AAI SUPPLIED MATERIALS	
RAPPELLING FIXTURE UPGRADE KIT P/N TB-09001-001	
Consists of:	
2	407-148-121 Decal
1	Installation Instructions, report AA-96201
1	Instructions for Continued Airworthiness, report AA-97042
CUSTOMER SUPPLIED CONSUMABLE MATERIALS	
Qty	Description
AR	Scotch-Brite Pad
AR	Isopropyl Alcohol
AR	Epoxy Polyamide Primer

ACCOMPLISHMENT INSTRUCTIONS

FIGURE 1. 407-148-121 DECAL MOUNTING LOCATIONS

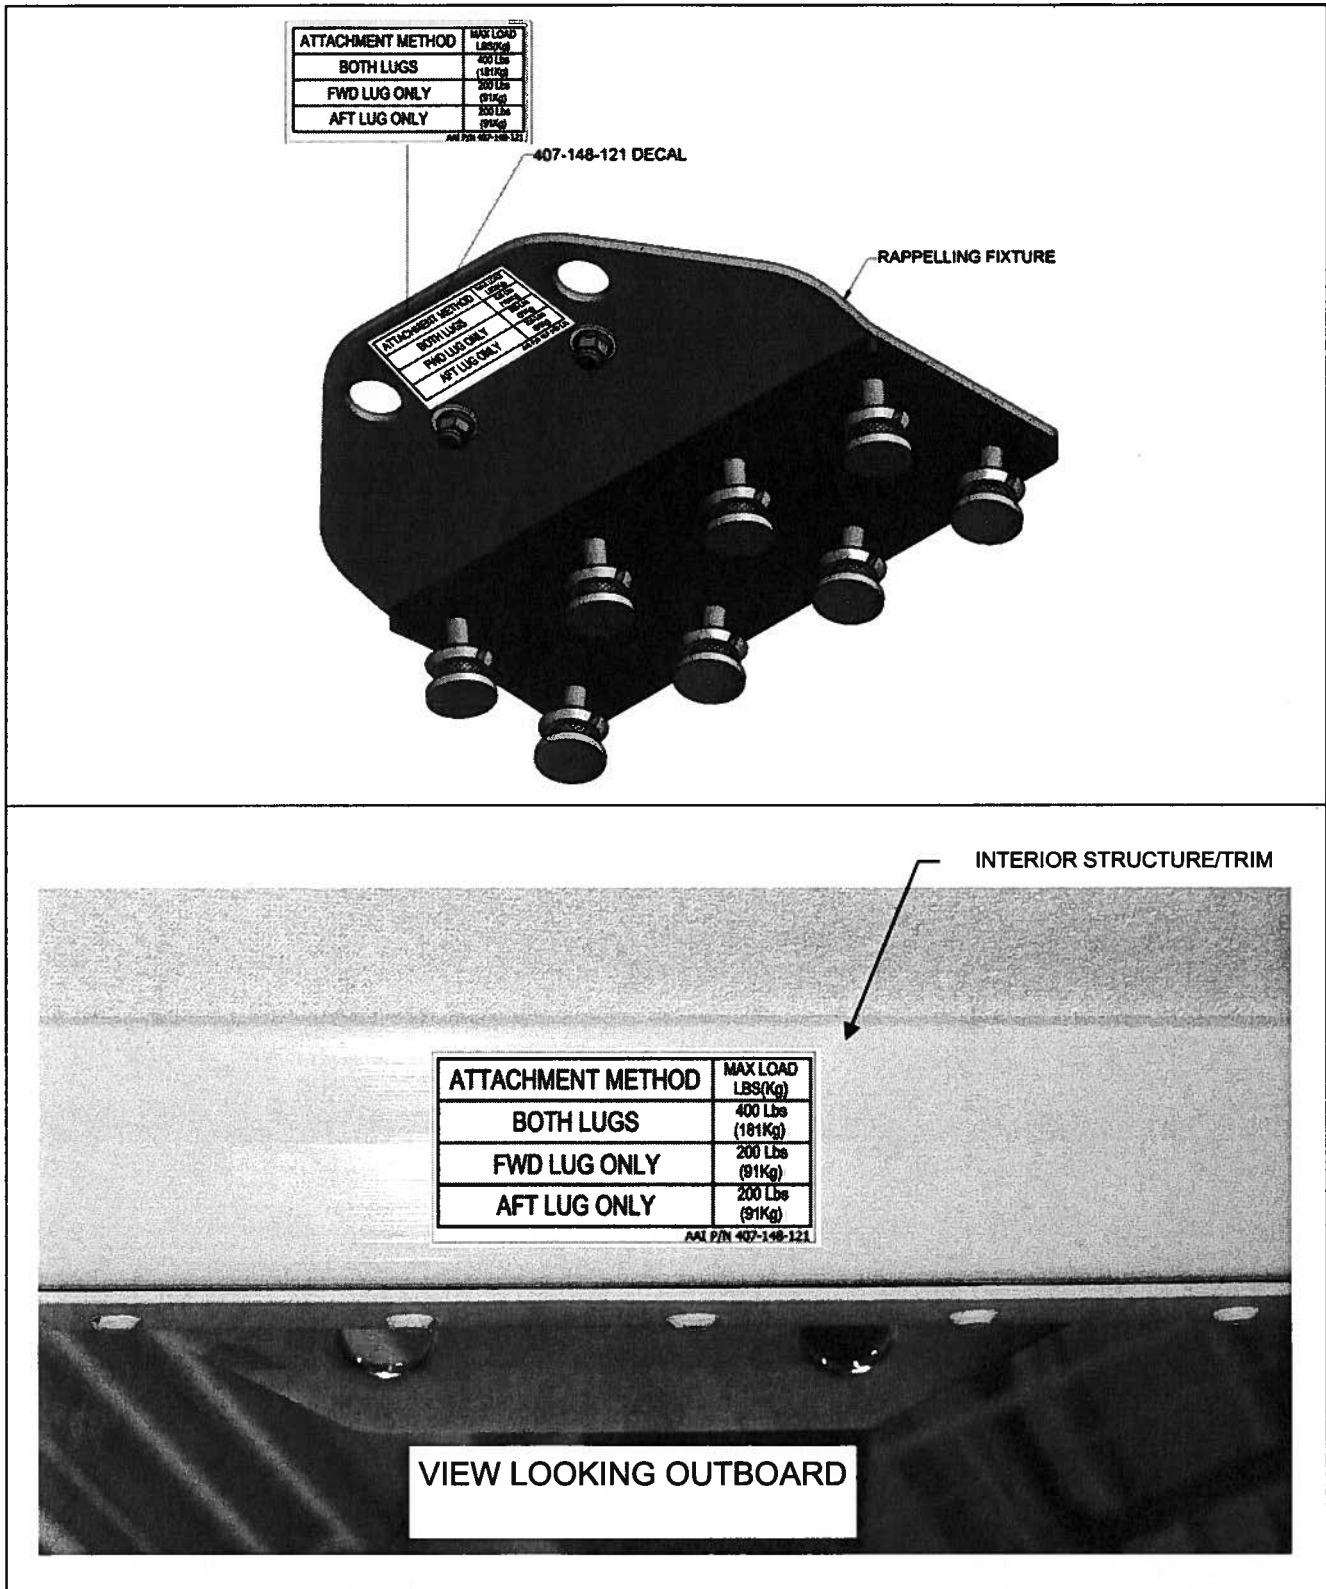
3. Upon receipt of materials, lightly polish the Rappelling Fixture decal area (see Figure 1) using Scotch-Brite pad. Take care to remove as little of the component protective coating as possible.

6. Paint repaired area to match existing finish, as required.
7. Apply decal (Figure 1) to Rappelling Fixture and aircraft interior structure/trim.
8. Note acceptable Rappelling Fixture load attachment as shown in Figure 2
